X23-575_867_603___GEO_EN_005___RVTO_MARCO_LUNETA__B-GUSS_KW29___170714_SE376_ACC_141020_003.CATPart

Analyze made against this part file name.

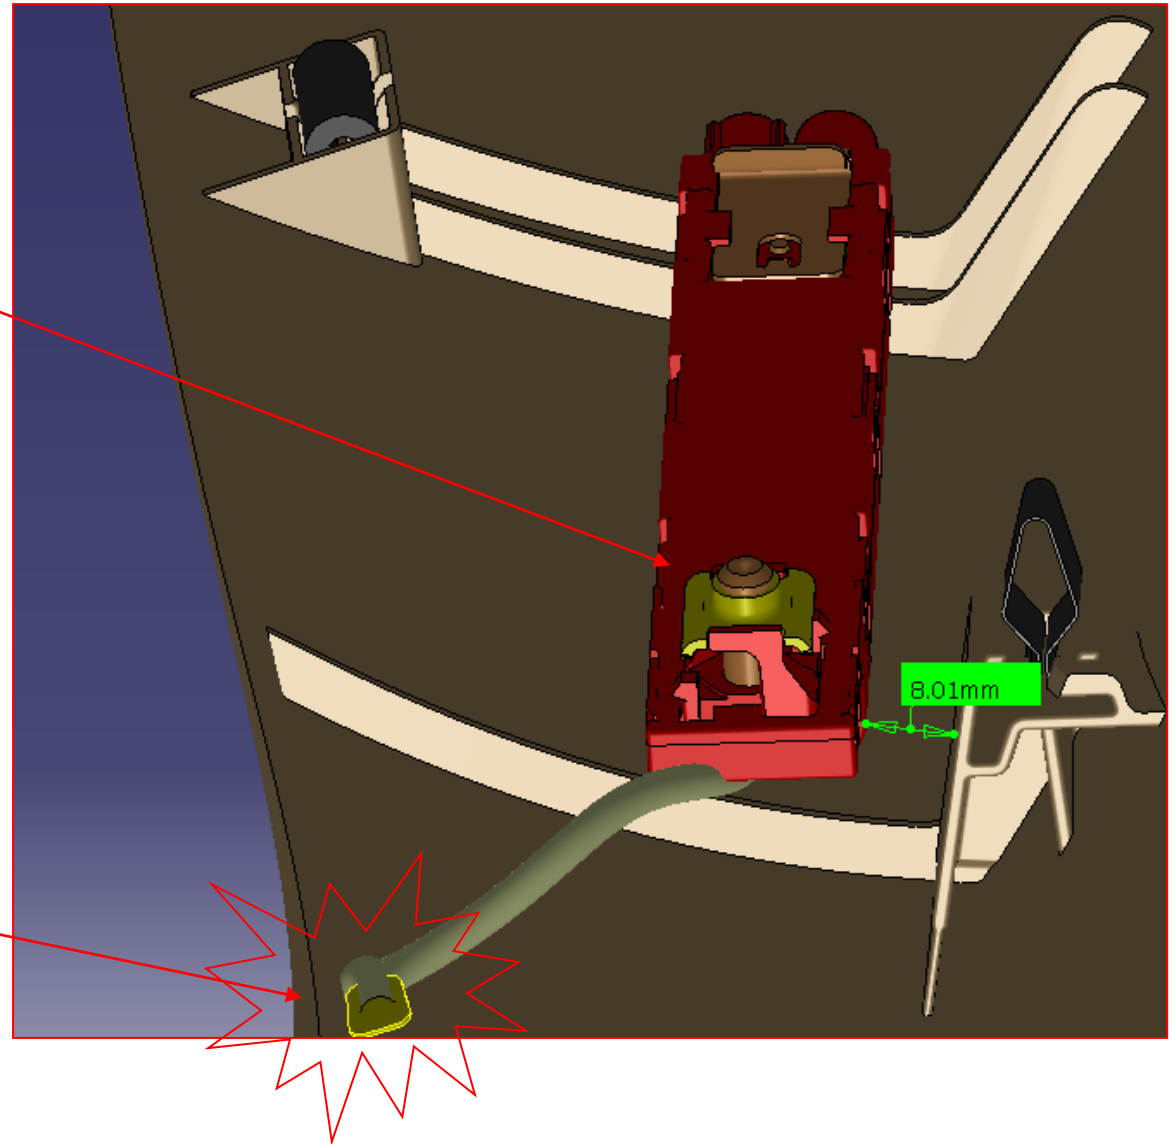
Minimum gap in X direction (real size) 8mm

Cable in clash

Notice: the cable was find in no show.

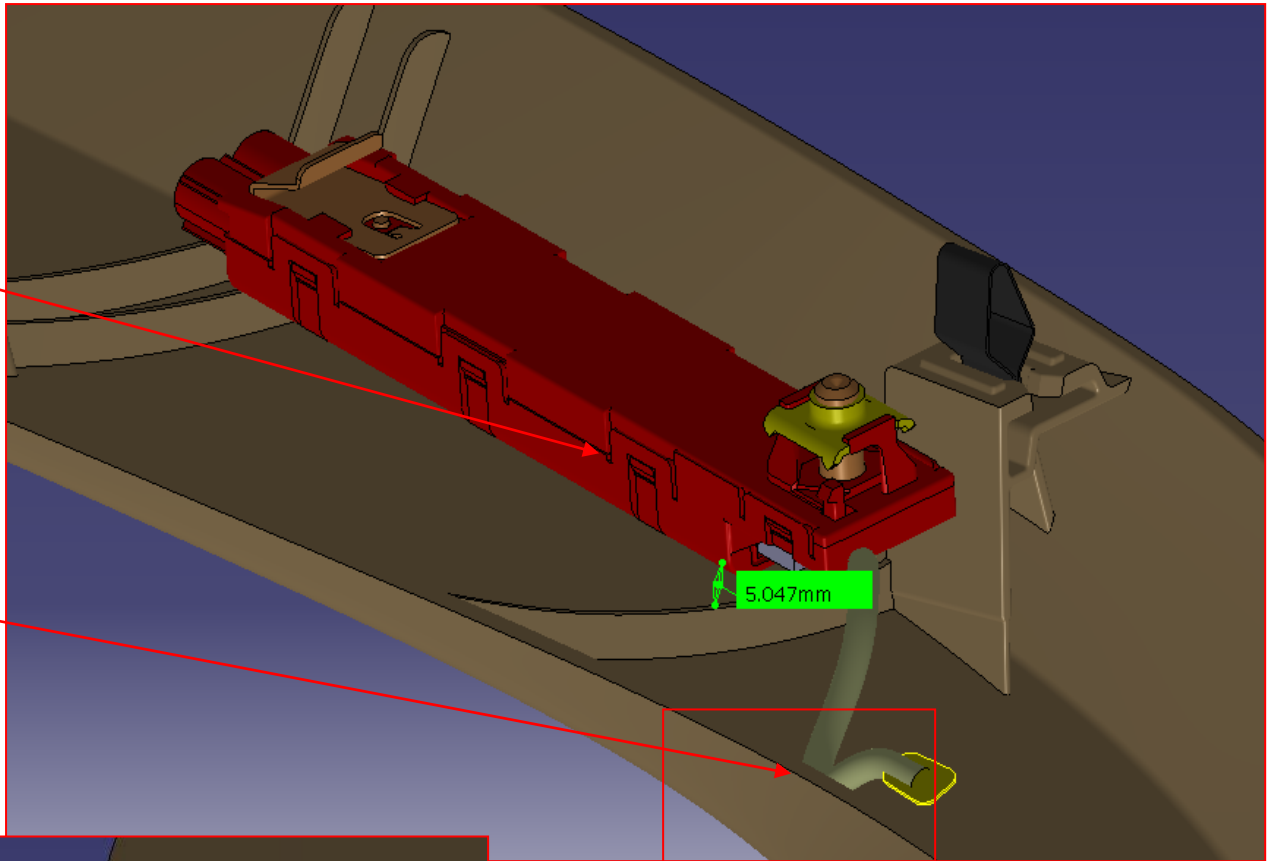
Minimum gap in Z direction (real size)
5 mm (rib high 5mm)

Cable in clash

Notice: the cable was find in no show.

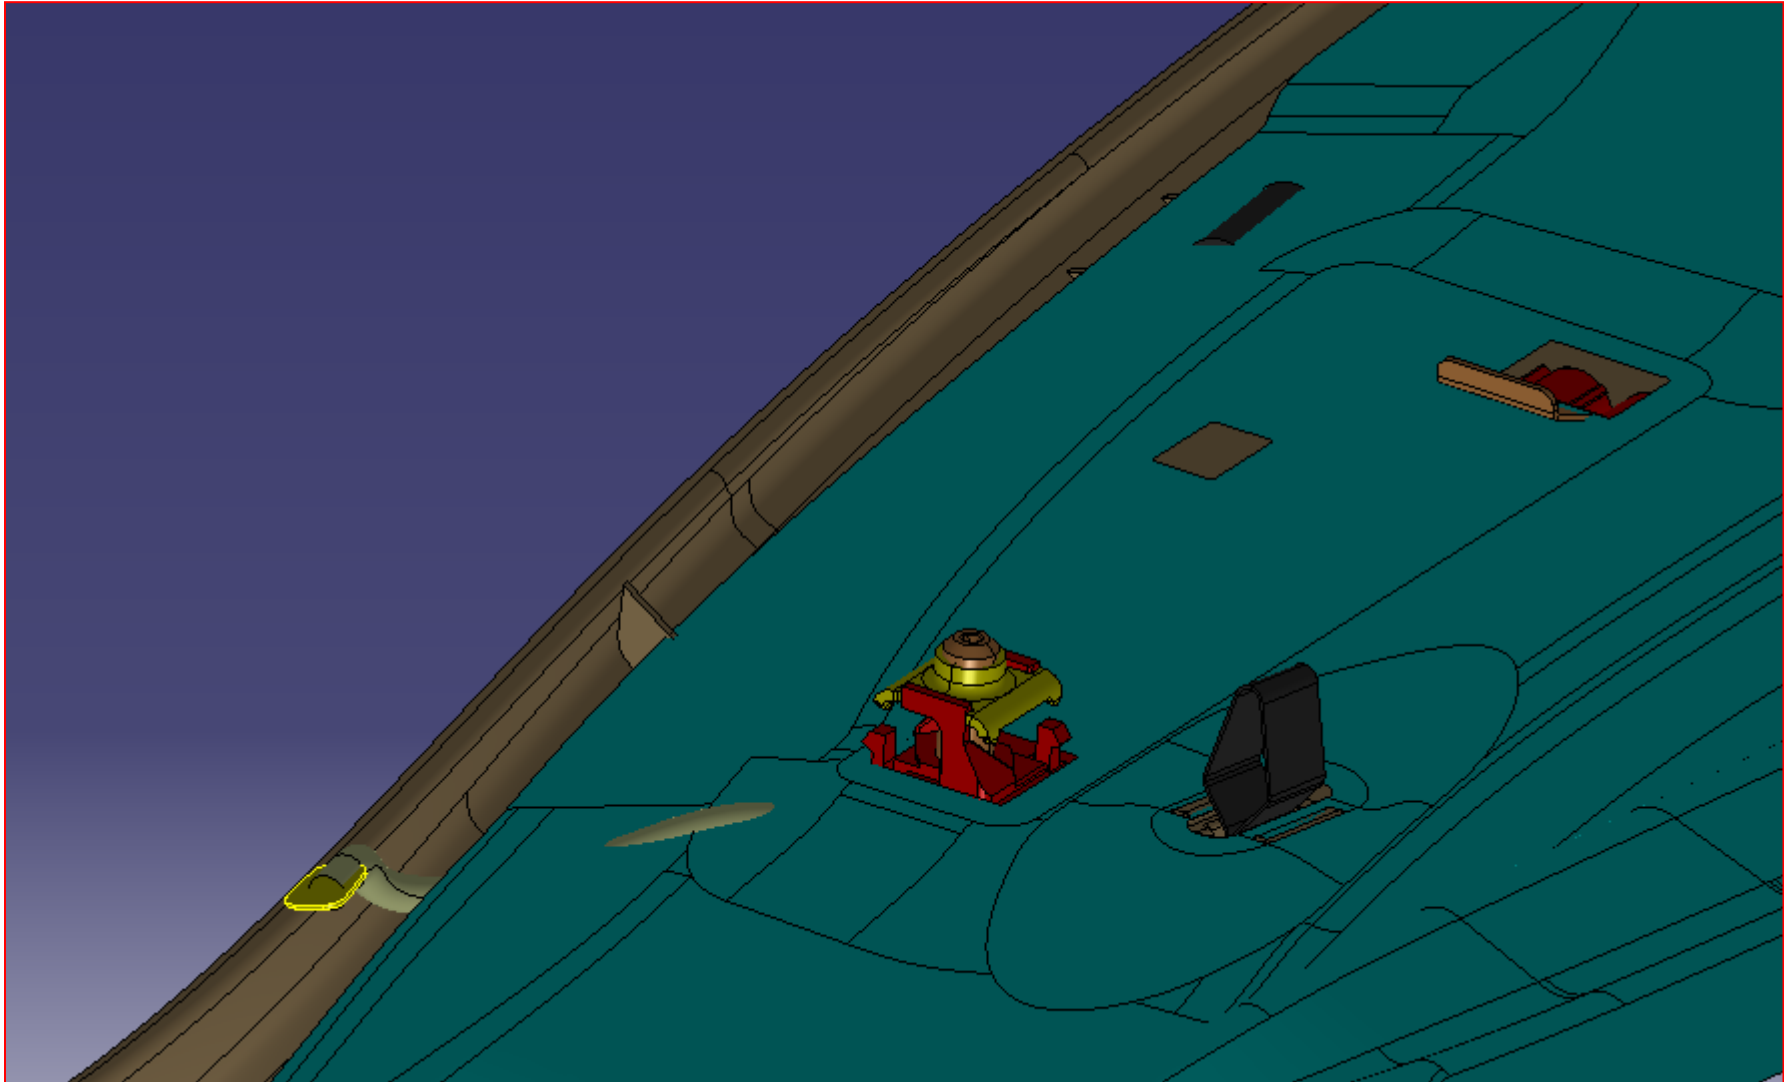
Clash max 0.21mm between upper
part EOP and cable
(EOP = end of part)

**SHOULD WE MAKE A CUTOUT
IN ORDER TO AVOID THIS
INTERFERENCE?
CLERANCE ?**

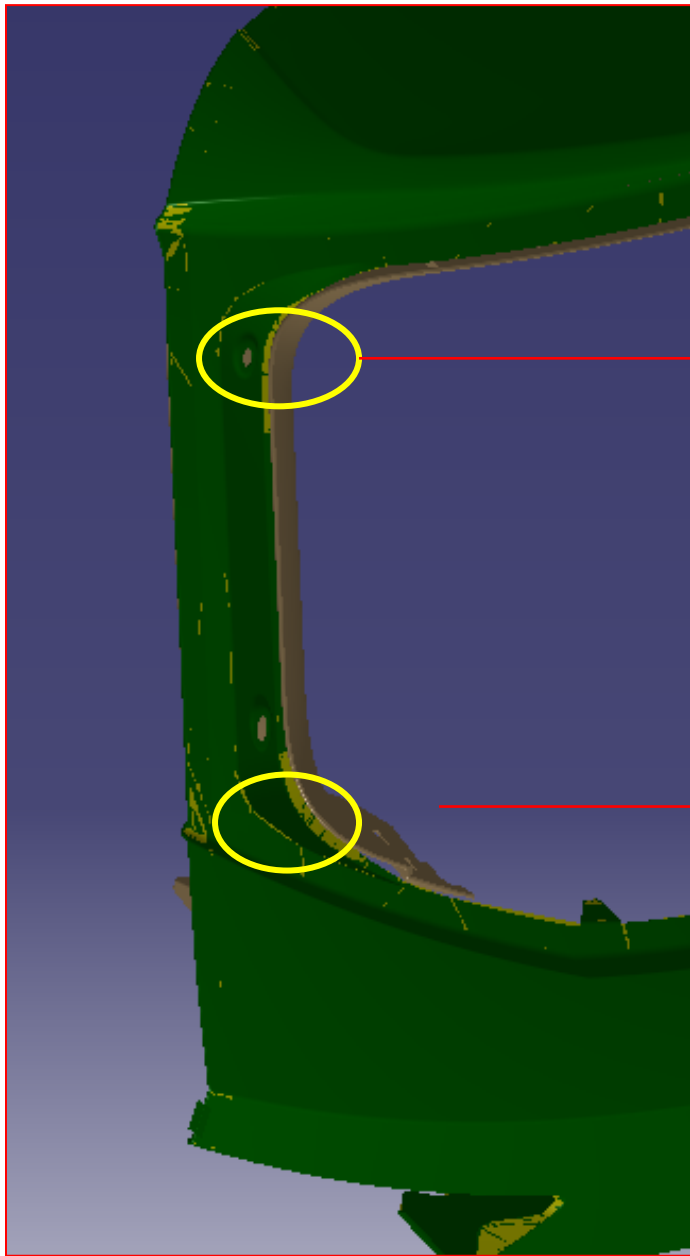
Clarence 0.5mm

PLEASE SPECIFY IF 0.413 IT COULD BE CONSIDERED CORRECT, OR, WE SHOULD PASS TO 0.5mm.

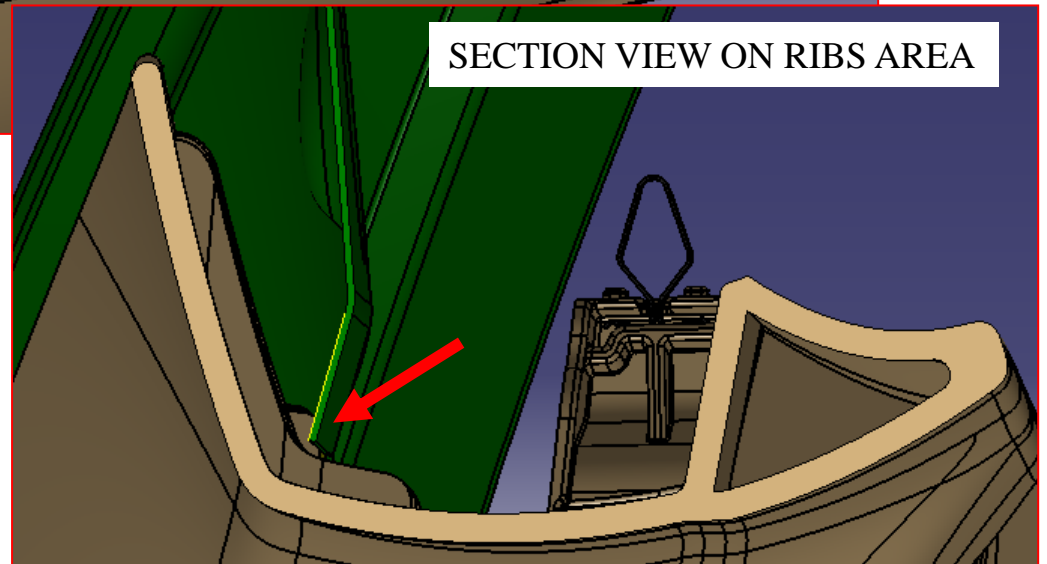
Side ribs proximity 1mm minimum.

PLEASE SPECIFY IF THE 1mm GAP IS GOOD ENOUGH (RIB HIGH 3mm).

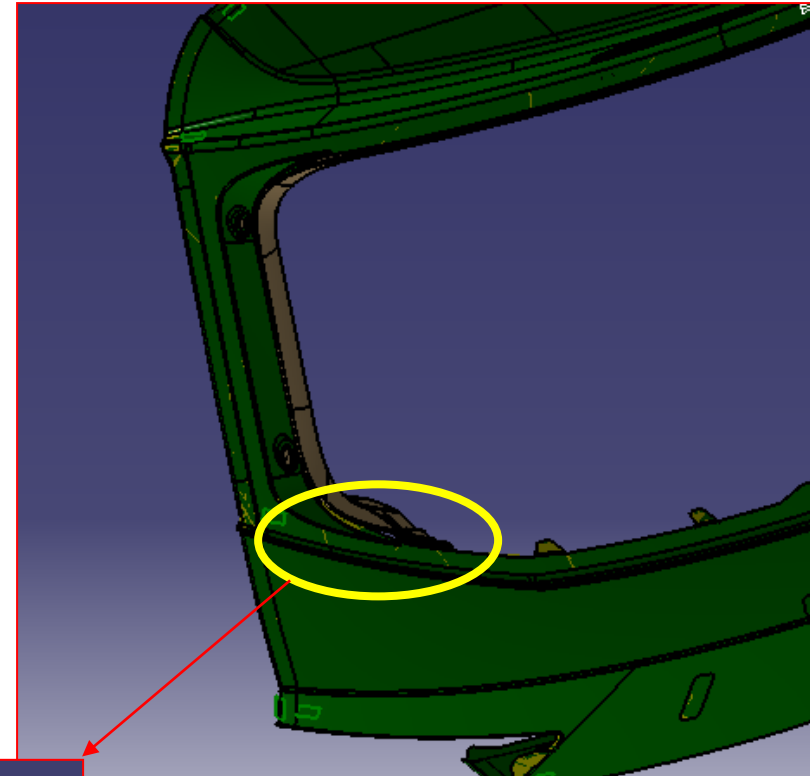
PLEASE SPECIFY IF THE 1.5mm GAP IS GOOD ENOUGH.

GAP 1.5 mm

**PLEASE SPECIFY IF THE
3 mm GAP IS GOOD
ENOUGH.**

It is
O.K.

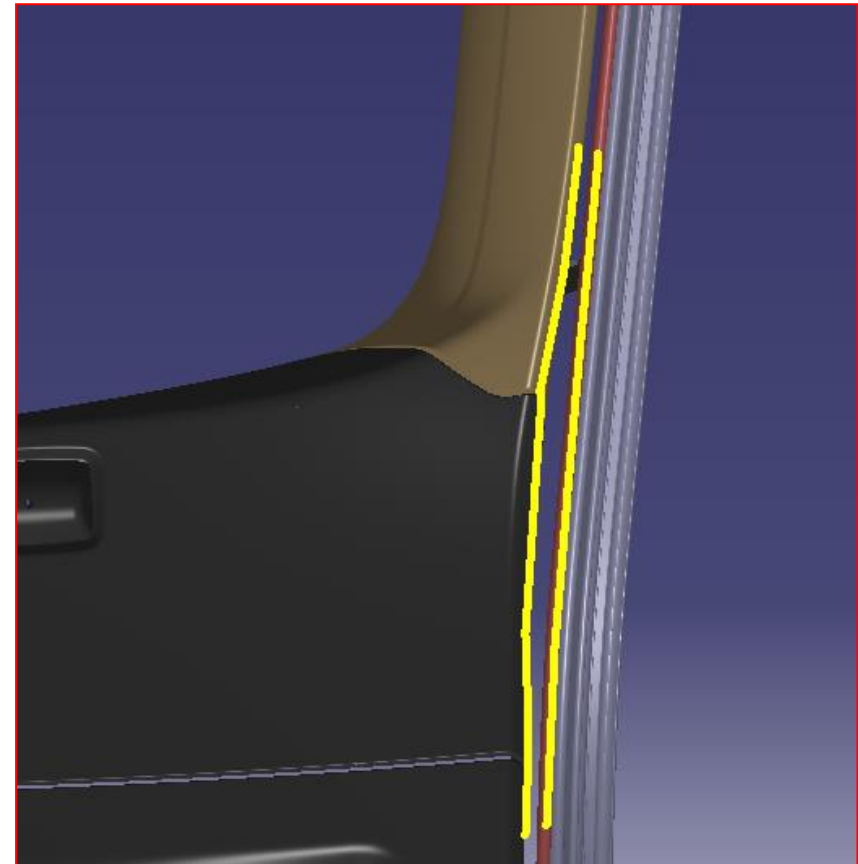
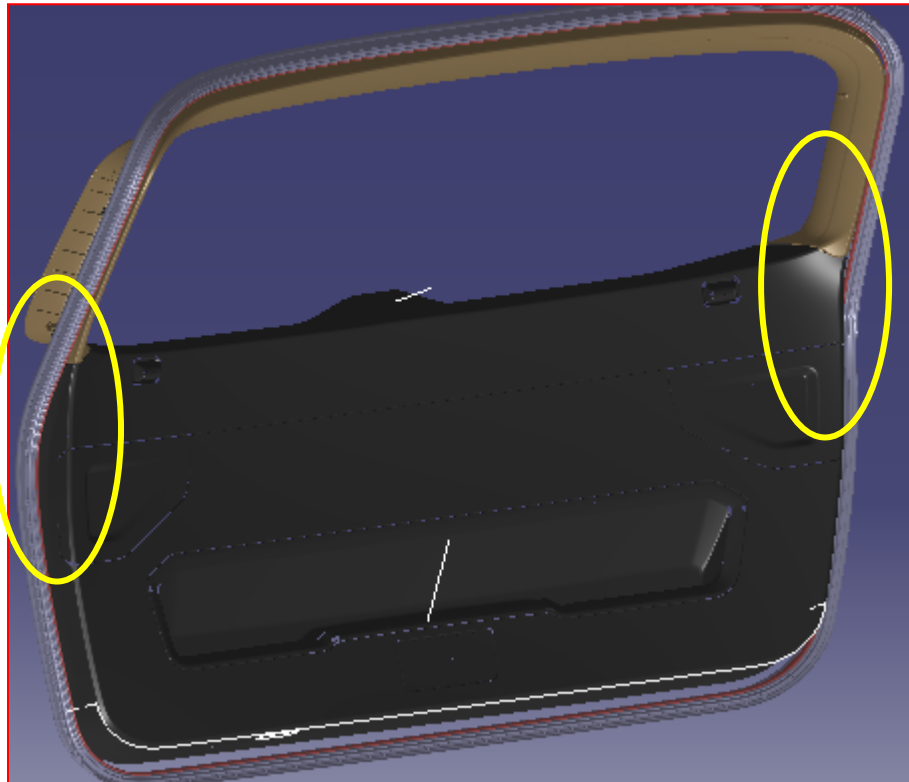
Remark:
Possible issue for style surfaces.

Appearance - not constant gap in this area

I will inform Seat in order to get a feedback

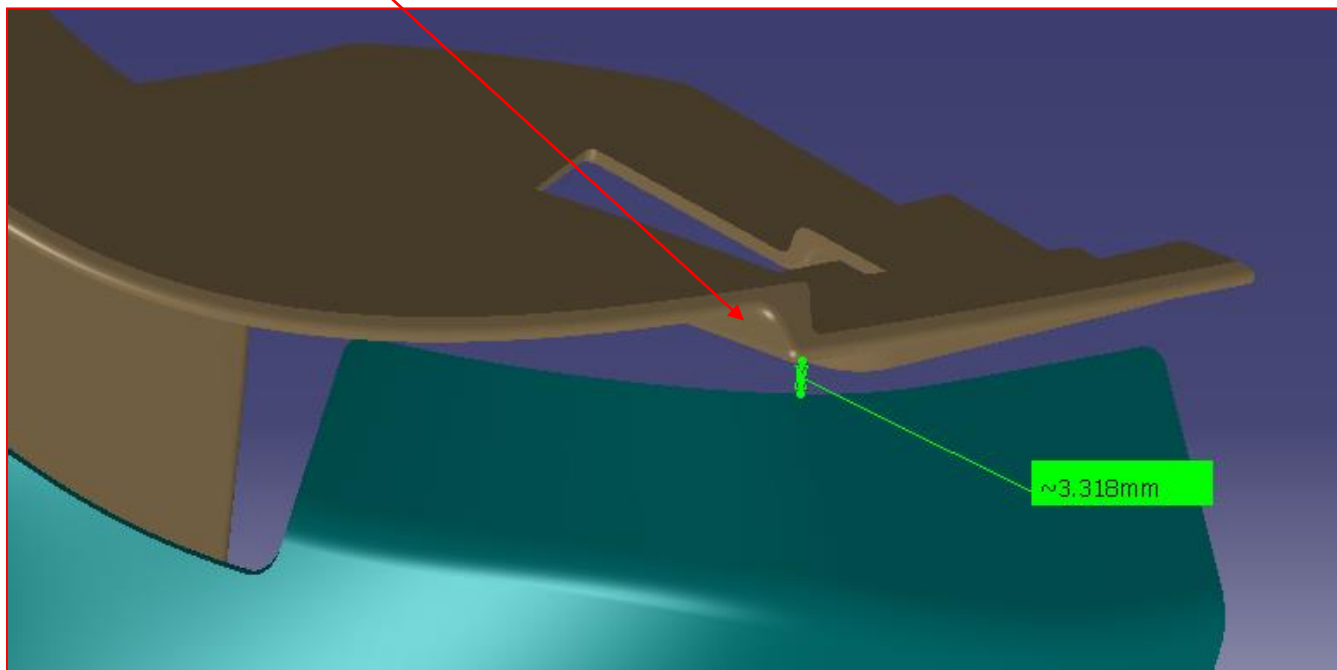
**PLEASE SPECIFY IF THE
3.3 mm GAP IS GOOD
ENOUGH.**

Gap 3.3mm in Z direction.

I will inform Seat in order to get a feedback

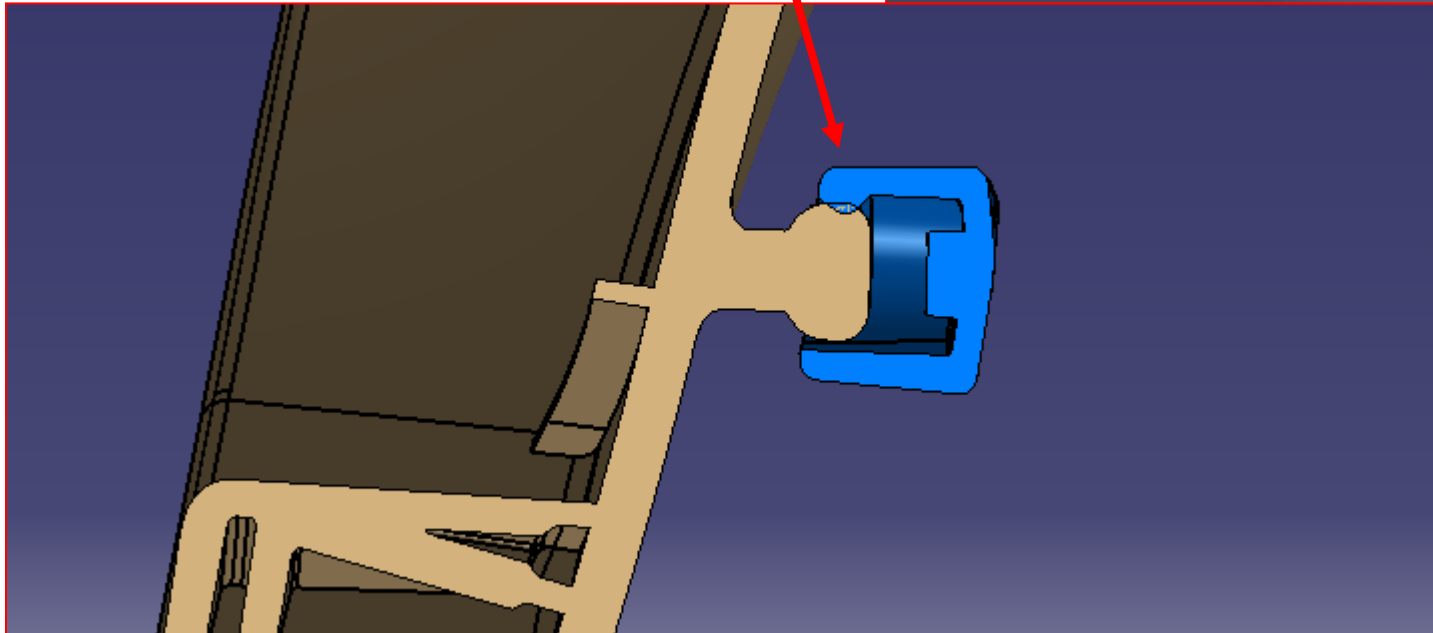
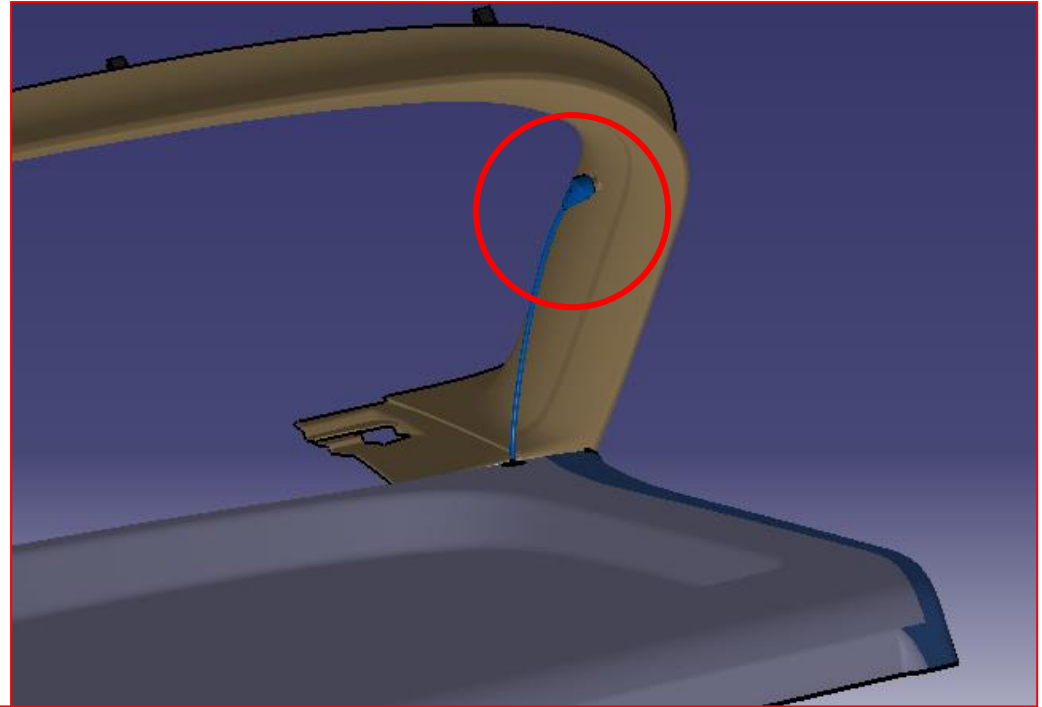
Remark:

Environment in wrong position

I have already asked for updated environment

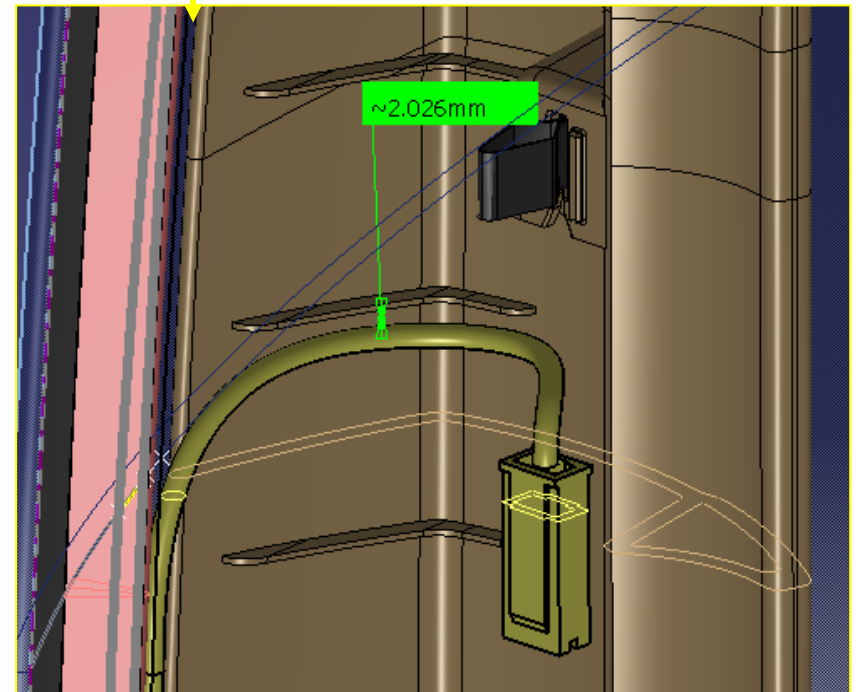
0.2mm colission

Proximity in Z direction 2mm

I will inform Seat about this issue
